January 25, 1971

Service of Snowthrower

WASHER TO BE
ADDED

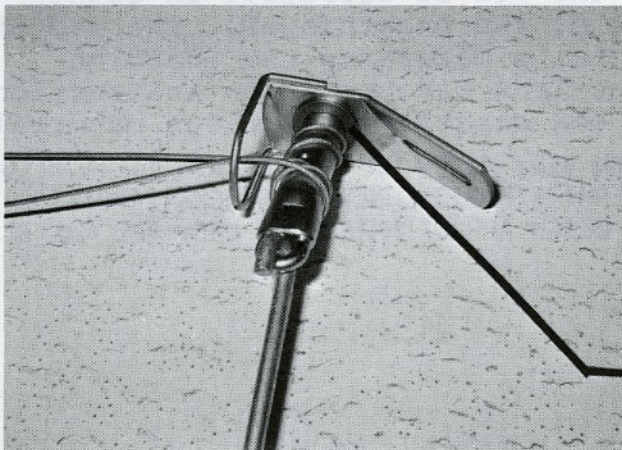
2. The chute rotating handle will perform much better with the use of the oil instead of grease as mentioned in #1 above. The addition of a washer to the cable wind-up spool will prevent the cable from being pinched between this spool and the spool mounting bracket. This washer should be 1" ID and 1-3/4" to 2" OD (std plain washer) and slipped over the spool so the washer is flush with the end of the spool that fits against the mounting bracket.
